# Access Compliance Report

## Public Rights-of-Way

Intersection ID: 28724	Main Street: NORTHWOODS_FOREST_DR	Cross Street: LAWING_SCHOOL_RD	Location:	N
ADA ID: 80425D952009	Ramp Type: Directional1	Initial Pass/Fail: Fail	Overall Compliance: No	Severity Score: 10
Codes/Mitigation Info/Possible Solution		Field Measurements/Component Compliance

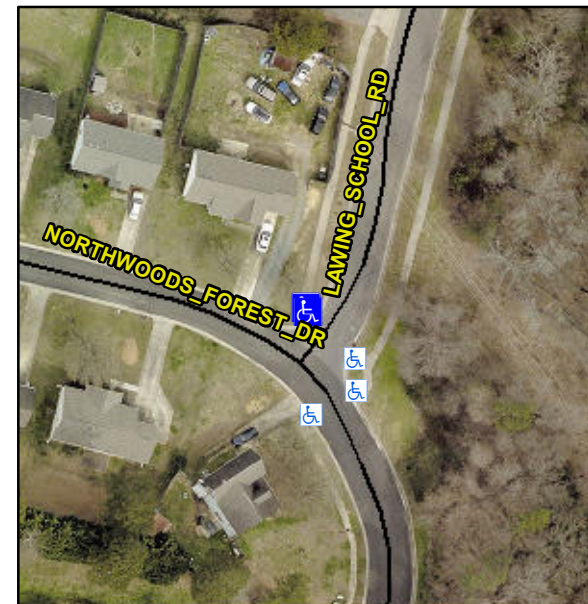
**Remove & Replace Entire Ramp.**

**R304.5.1, R304.5.3**
